Addendum III
to
Environmental Impact Assessment
for the Development of a 200 bed Tourist Hotel on
G. Dh. Magudhdhuvaa

Since the beginning of the construction phase of the 200 bed resort project by Ahmet Aydeniz Pvt. Ltd. authorized by the MHTE (MEEW at the time) through a decision note (88-ES/NI-MAG/2008/3), a number of issues have arose and a number of changes in the site plan have been made. Since some of these have an implication in terms of environmental impacts, MTDC, Ahmet Aydeniz Pvt. Ltd. and the environmental consultant were notified during a meeting with EPA that an amendment to the initial EIA should be submitted to get an authorization for these new developments. The present addendum is the third for this project, and deals with three major issues:

Figure 2: proposed layout of the resort at G. Dh. Magudhduvaa with major changes from previous approved designs highlighted in blue.

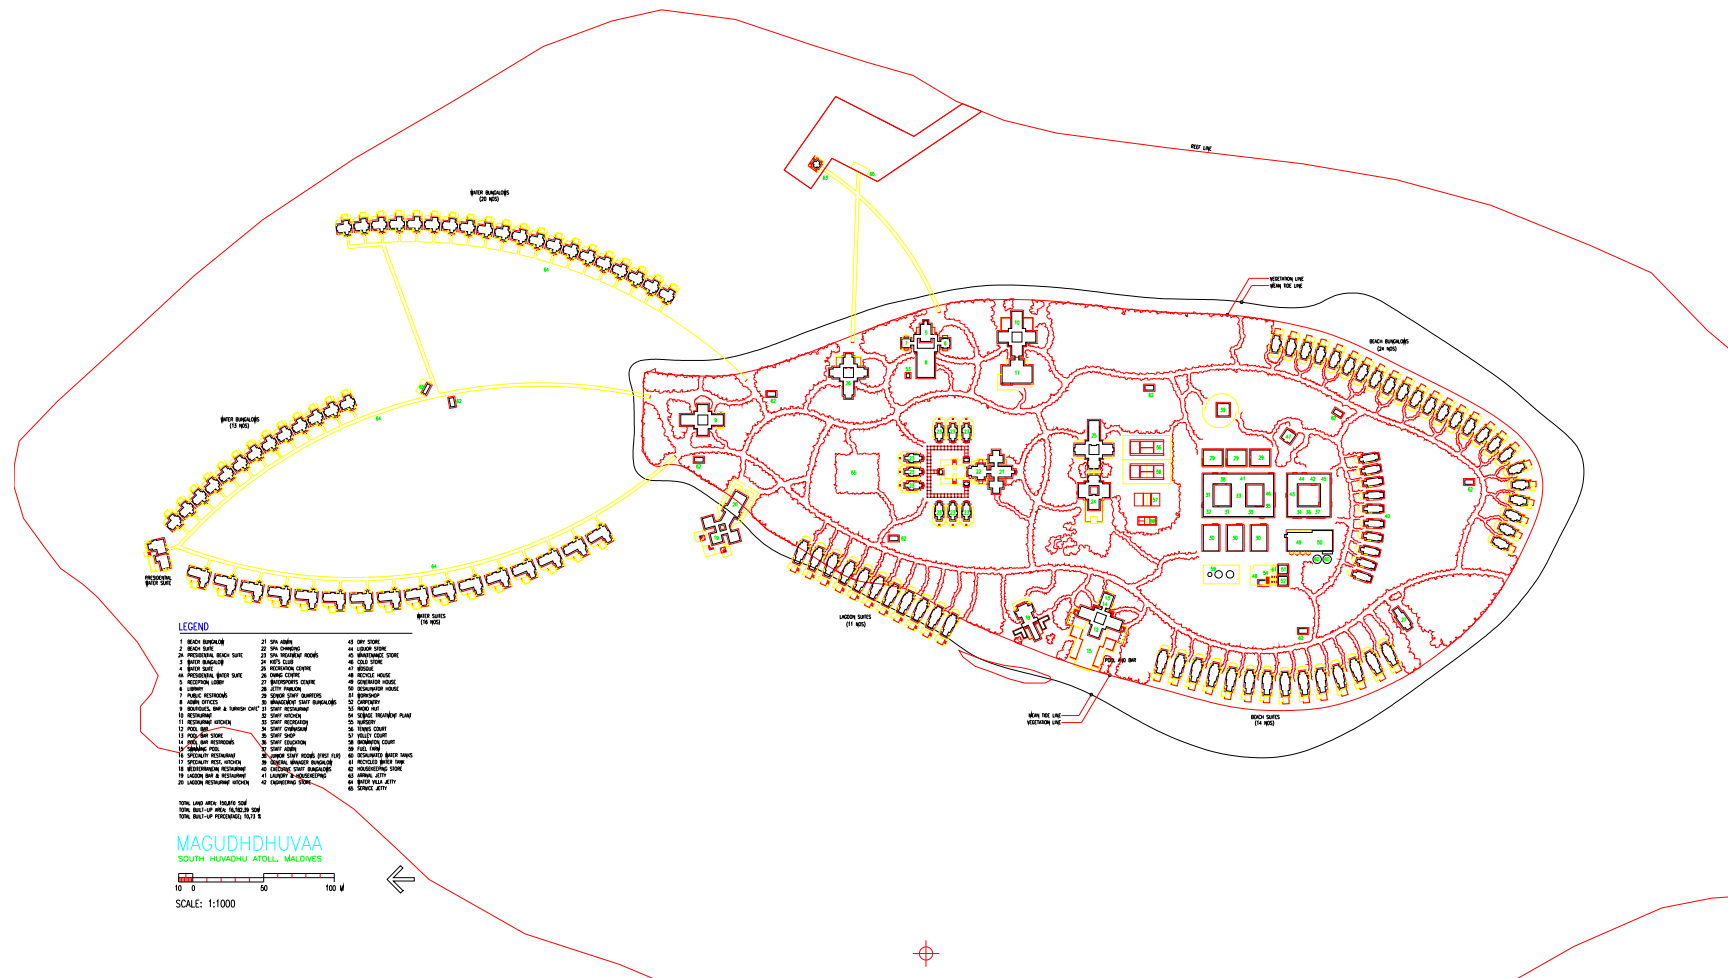
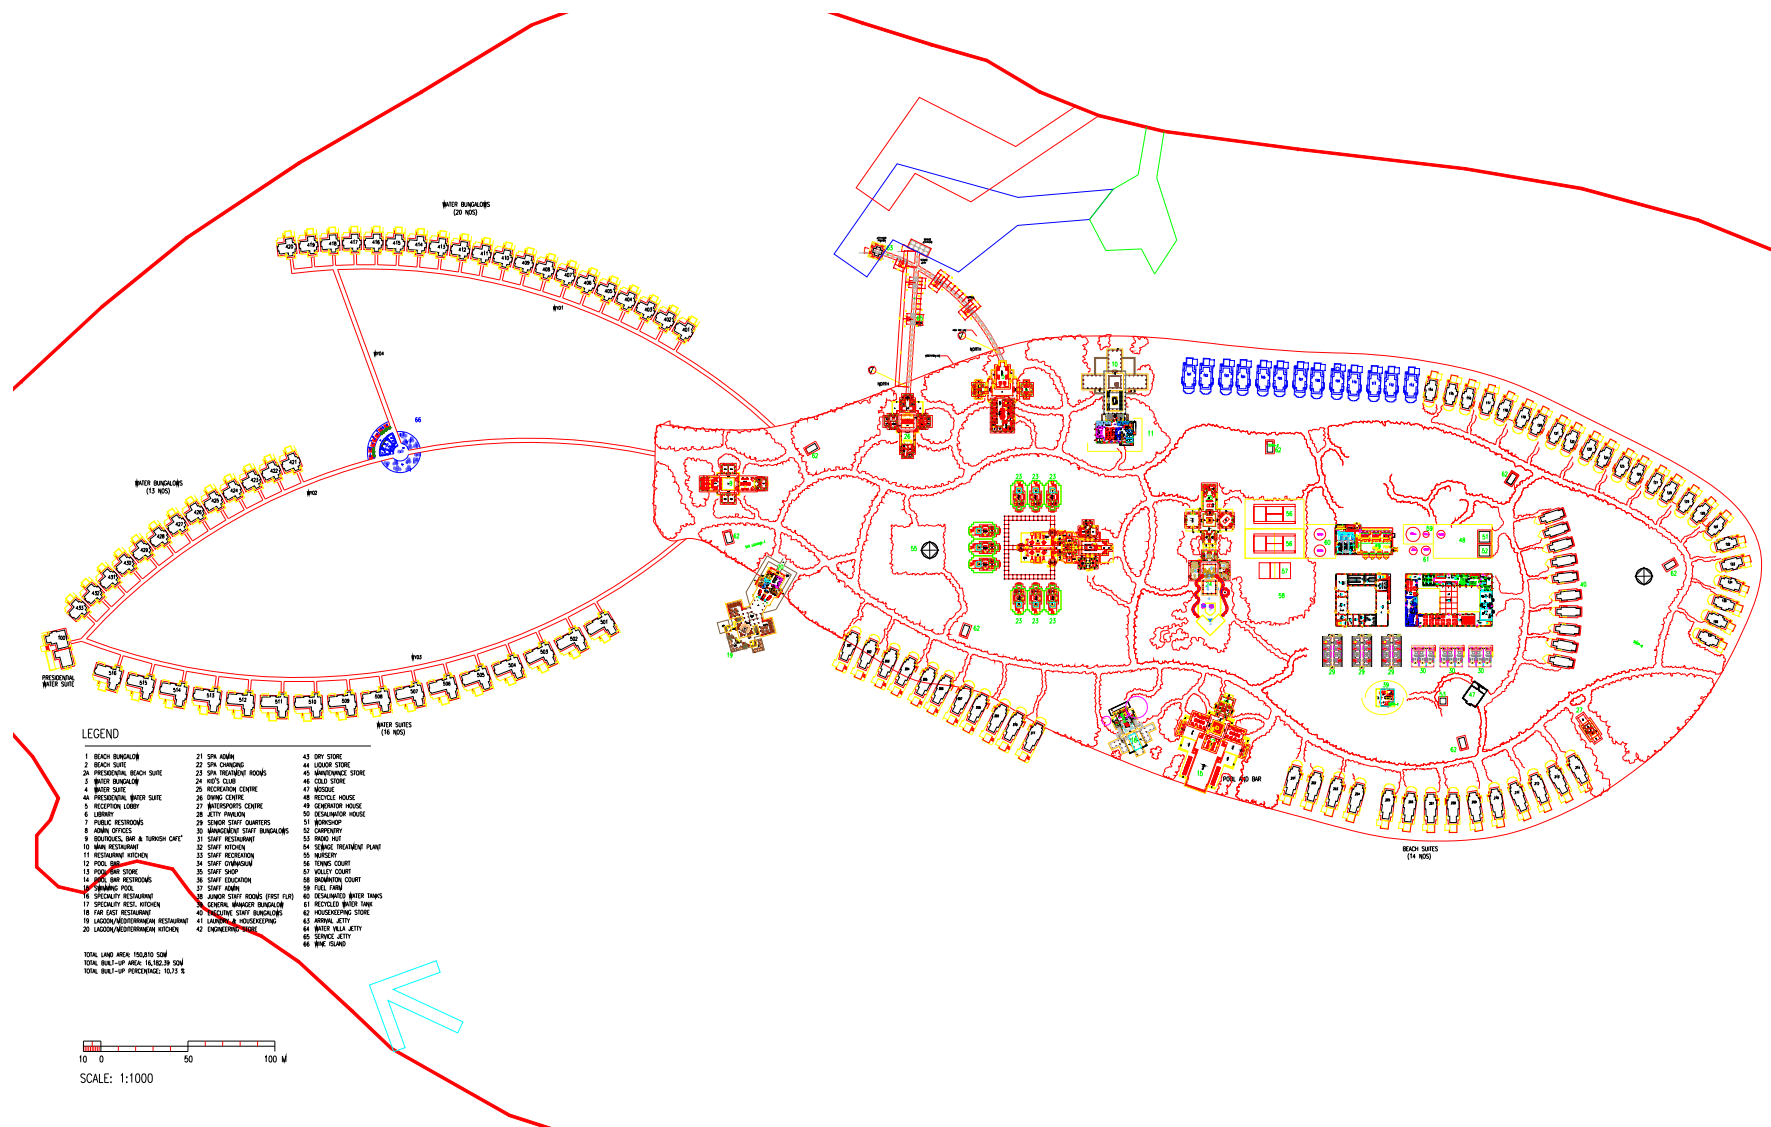
The new layout of the resort in Magudhdhuvaa is presented below (Fig. 2), as well as the layout previously submitted in Addendum II, are included here for reference (Fig. 1).

The main differences in the two layouts are the ones outlined above

- a) Harbour basin shape modification
- b) 13 additional bungalows on the eastern side
- c) Jetty enlargement and refreshment area on the northern reef flat

Figure 3: Changes to the harbor basin, in red the previously proposed harbor, in blue the proposed new harbor shape in green the existing temporary harbor, and hatched green, the area which will be filled before opening.

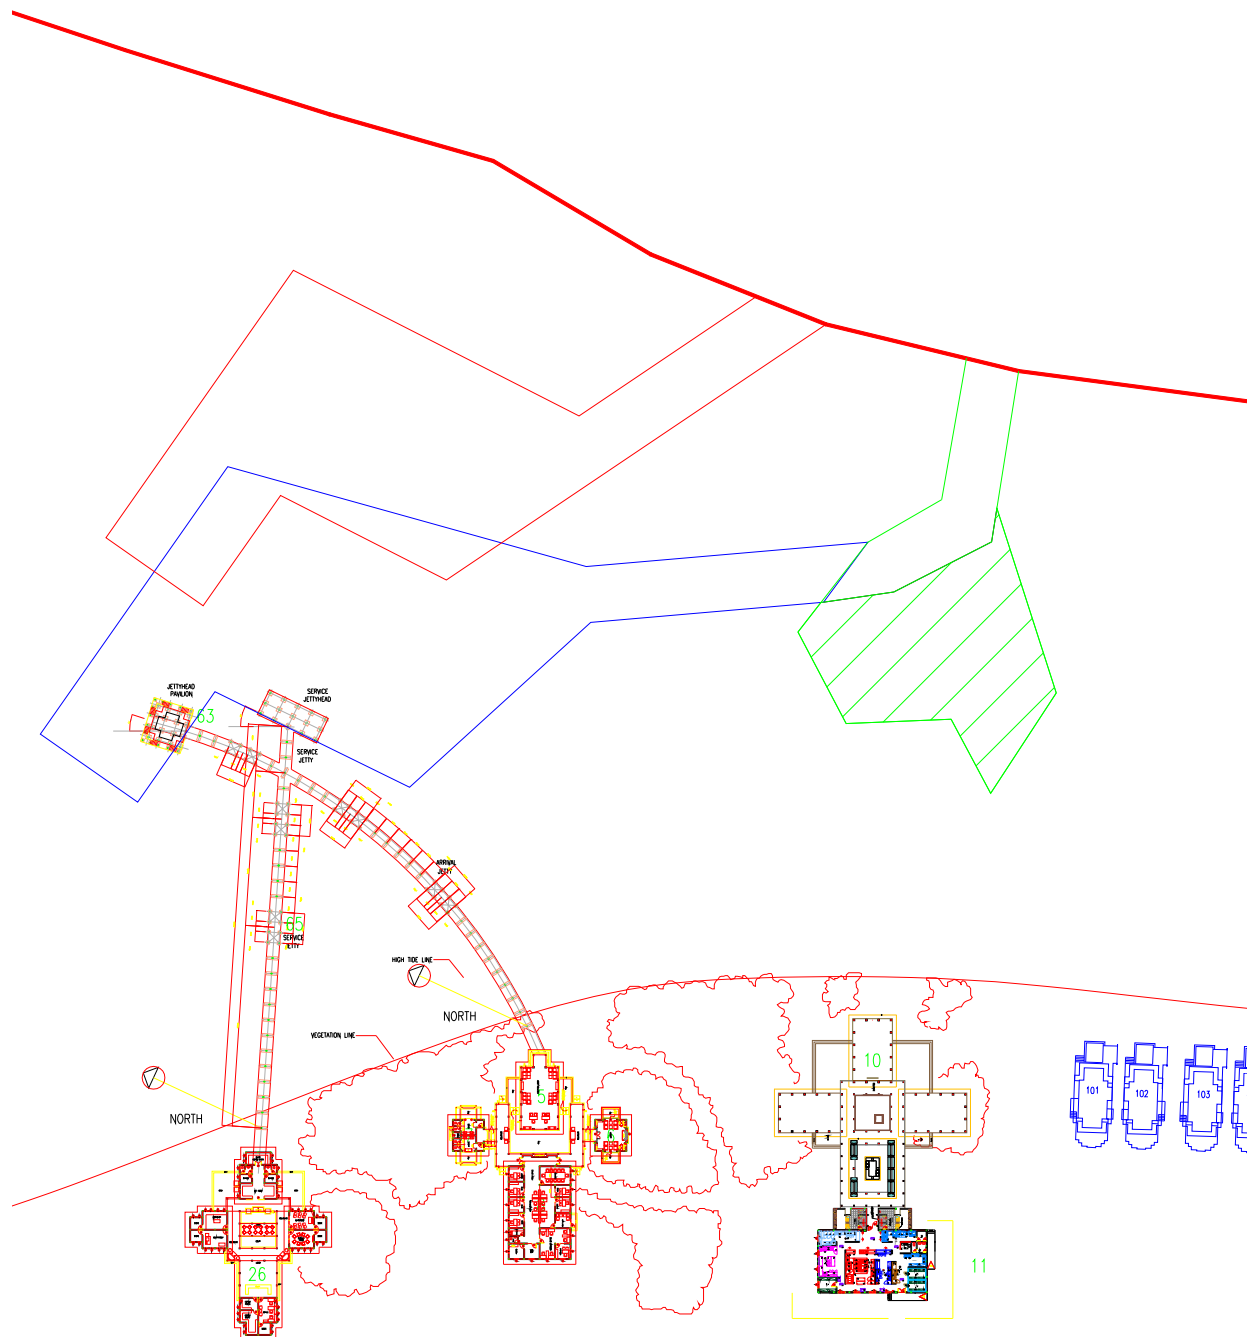
Due to a mistake in the location of the channel during the construction phase, the channel which was open on the east side of the reef to allow for boats to come inside the lagoon is too far south. In order to avoid the creation of another channel very close by, which would further weaken the island by enabling larger amount of wave energy to enter the inner lagoon and the shoreline; it is proposed to revise the shape of the harbor before it is excavated.

The arrival jetty has been shortened in the latest design, which allow for the harbor basin to be located closer to the shore. This has rather positive environmental implications, as the harbor basin will therefore be located further from the reef crest and live coral areas.

The following drawing (Figure 3) compares the situations in the two drawings, and shows in addition, the present temporary harbor dredged area, and the previous shape of the harbor with the extended jetties.

The overall surface area remaining to be excavated is 4700 m², to a depth of approximately 2.5 m below MSL. The volume of sand excavated is approximately 9000 m³. This compares with the 3700 m² of the previously proposed harbor, which would in fact yield more material and especially more rocks given that the crest is shallower and rockier than the internal lagoon. The previous approved design would have required excavation of 8000 m³. It is expected that the filling of the existing basin as proposed in figure 3 will require 1000 m³ of material.

Figure 4: the 13 additional bungalows located on the eastern beach between the previously built bungalows and the main restaurant.

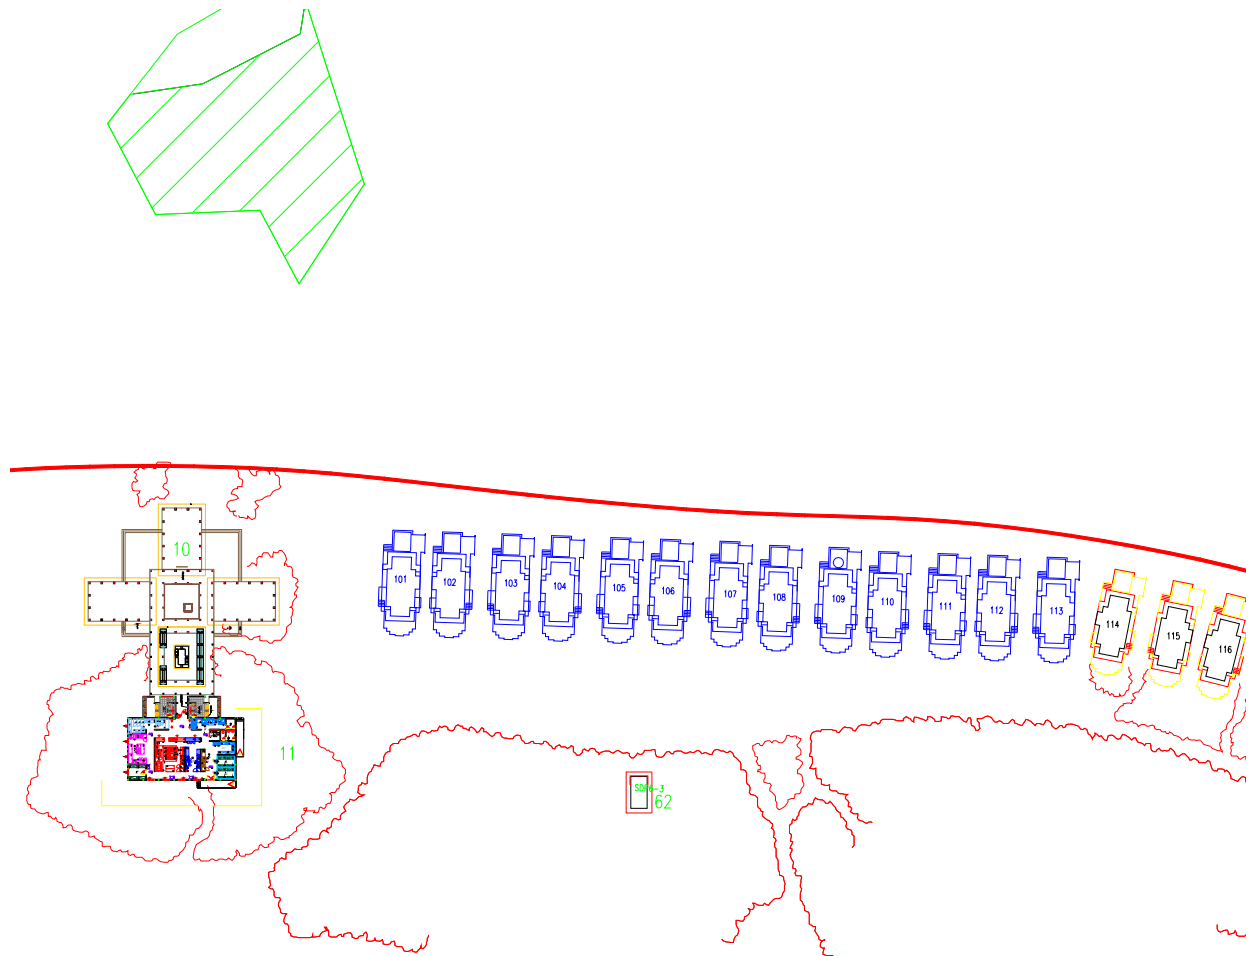
Pending the approval of the additional 13 bungalows by the Ministry of Tourism, Arts and Culture, an area was left without construction on the eastern side of the island. The MoTAC has now approved of the additional 13 bungalows which have been located in this area (Fig 4).

Figure 5: Top view of the jetty enlargement area

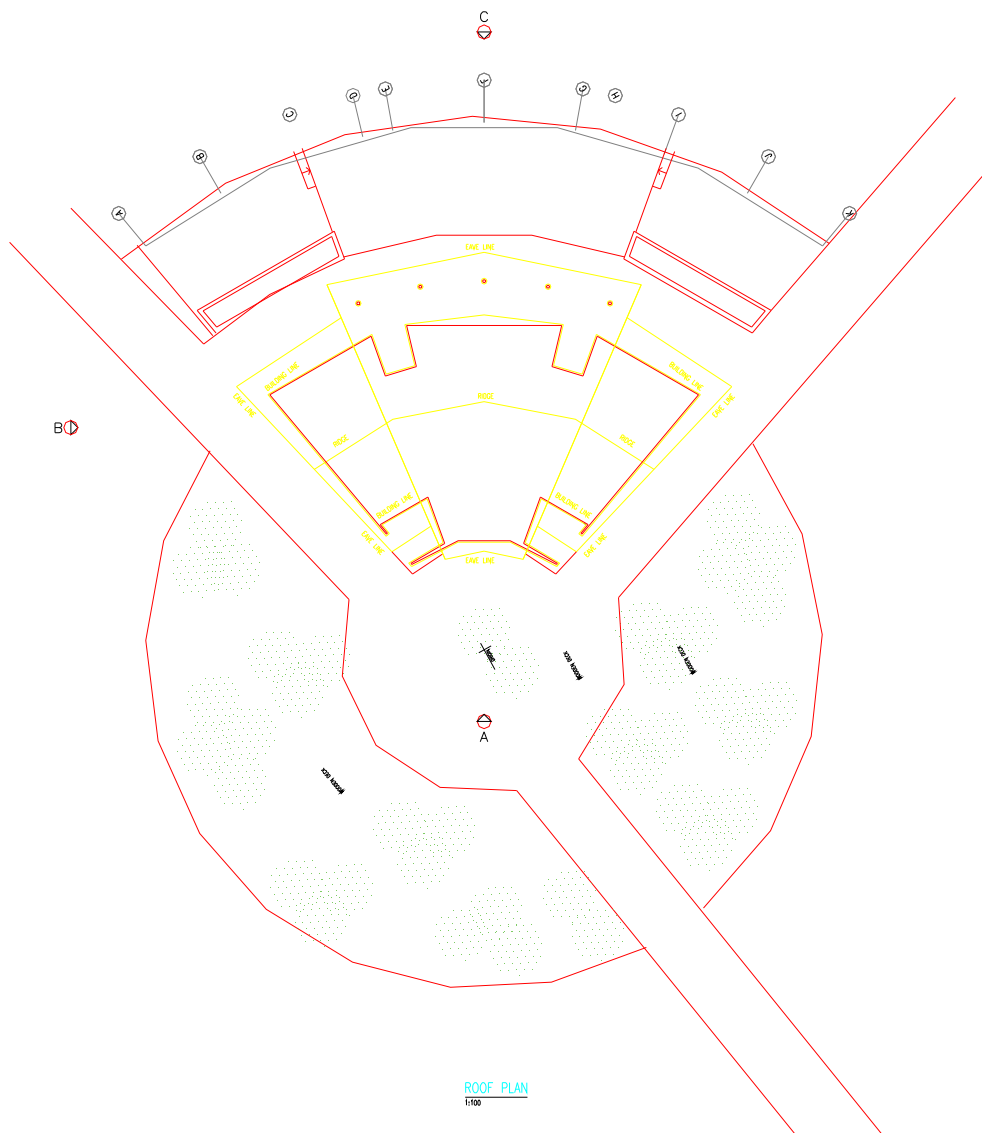
In order to provide a break to the people moving back to their water villa, Ahmet Aydeniz Maldives proposes to enlarge the deck area where the two jetties from the string of water villas meet. Refreshments will be proposed in this area, which will also be planted with greenery. To achieve this, some large concrete pots will be incorporated. The structural and architectural designs for this development are presented below (Fig. 5, 6 and 7).

Figure 7: layout of the additional footings in the area

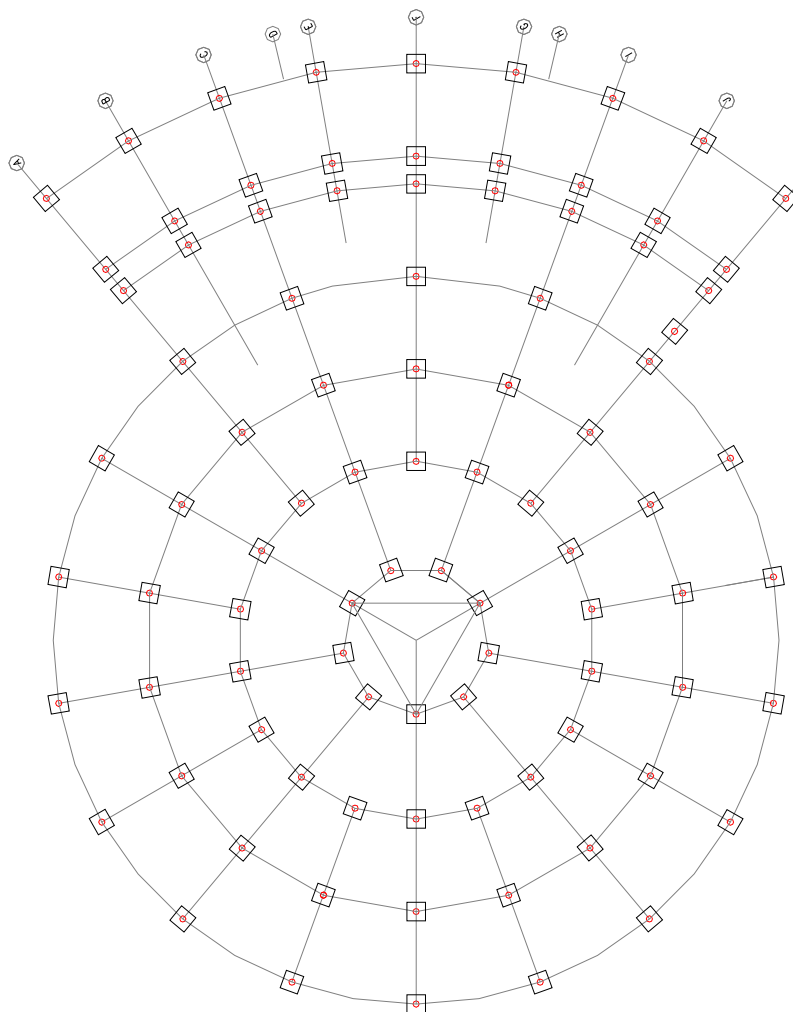
100 pillars will be added to the ones already approved. The design of the pillars is provided in figure 8. Similarly, the piles will be laid in a pit excavated in the sea bed. The machinery used is a heightened version of a usual excavator. With this, the operator can drive and operate the bucket in depth of around 1.5 m present in this area.
